**2<sup>nd</sup> Further Information**

**Proposed Temporary Warehouse (Excluding Dangerous Goods Godown) with Ancillary Facilities  
for a Period of 3 Years and Associated Filling of Land in "Agriculture" Zone,  
Various Lots in D.D. 117, Tai Tong, Yuen Long, New Territories**

**(S.16 Planning Application No. A/YL-TT/650)**

Responses-to-Comments

DWG. TITLE  
 LANDSCAPE PROPOSAL

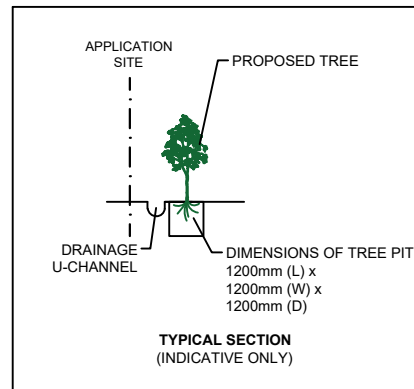
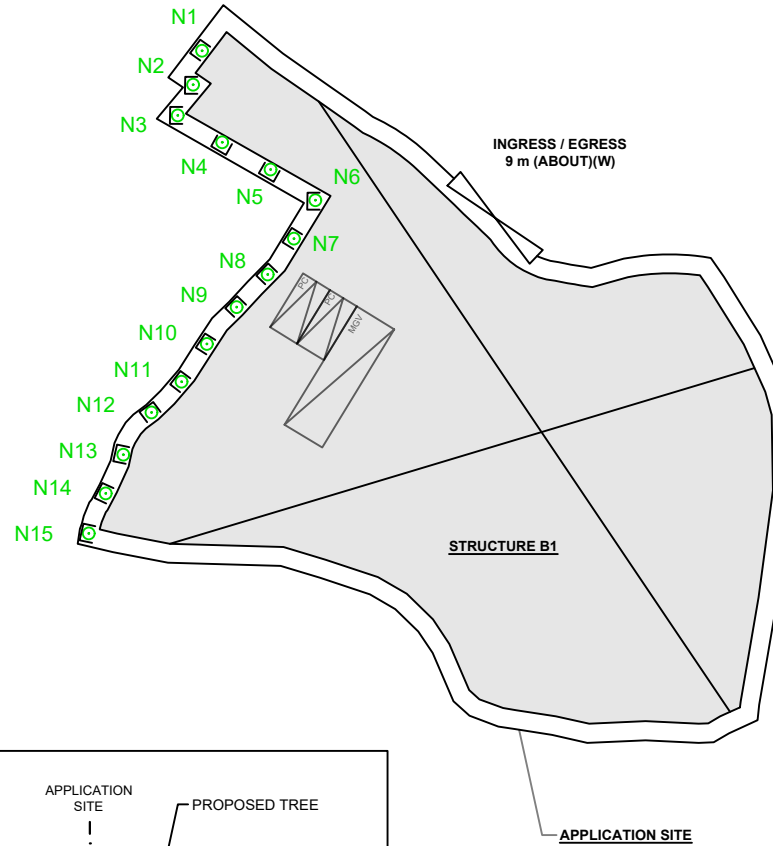
Departmental Comments	Applicant’s Responses
<b>1. Comments of the Chief Town Planner / Urban Design and Landscape, Planning Department (CTP/UD&amp;L, PlanD) (Contact Person: Mr. LAM; Tel: 3565 3949)</b>	
<p>(i) Existing trees and vegetation within the Site were observed. However, the proposed filling of land with concrete (the entire site) would cause the adverse landscape impact on the existing trees/vegetation within the Site. Significant impact on the existing landscape resources is envisaged. Moreover, the proposed mitigation measures (i.e. the proposed vertical greening with climber species on the fence along the site boundary) in the landscape proposal enclosed in the FI(1) could not mitigate the impact generated by filling of land and consequently cause the removal of all existing trees and vegetation within the Site. The applicant should consider to explore planting of new tree as the mitigation measures.</p>	<p>According to the tree survey conducted on 13/09/2024, a total of <u>15</u> nos. of trees are recorded within the Site (<b>Annex I</b>). No old and valuable tree or protected species has been identified in accordance with the DEVB TC(W) No. 5/2020 – Registration and Preservation of Old and Valuable Trees and the Forests and Countryside Ordinance (Cap.96). Due to the proposed hard-paving works for site formation of structures and circulation purpose, all existing trees will be affected, and it is not proposed to retain any of the existing trees within the Site.</p> <p>Due to the felling of existing trees within the Site. A landscape proposal is submitted by the applicant to provide landscape mitigation measures for the proposed development (<b>Annex II</b>). <u>15</u> new trees (N1 to N15) are proposed to be planted along the west and northwest periphery boundary of the Site as a landscape buffer to minimise adverse visual impact to the surrounding areas. All these new trees within the Site will be maintained by the applicant during the planning approval period.</p>

APPLICATION SITE AREA : 1,835 m<sup>2</sup> (ABOUT)  
 COVERED AREA : 1,539 m<sup>2</sup> (ABOUT)  
 UNCOVERED AREA : 296 m<sup>2</sup> (ABOUT)  
 NO. OF NEW TREES WILL BE PLANTED : 15 (N1 TO N15)  
 SPECIES OF NEW TREES : *SENNA SURATTENSIS*  
 HEIGHT OF NEW TREES : NO LESS THAN 2.75 m  
 SPACING OF NEW TREES : NOT LESS THAN 4 m  
 DIMENSION OF TREE PITS : 1.2 m (W) X 1.2 m (L) X 1.2 m (D)

- 1) THE APPLICANT WILL MAINTAIN TREES IN GOOD CONDITION DURING THE PLANNING APPROVAL PERIOD.
- 2) THE APPLICANT WILL REPLACE TREES WHICH ARE DYING OR DEAD DURING THE PLANNING APPROVAL PERIOD.
- 3) THE APPLICANT WILL PROVIDE ADEQUATE IRRIGATION FOR TREES.
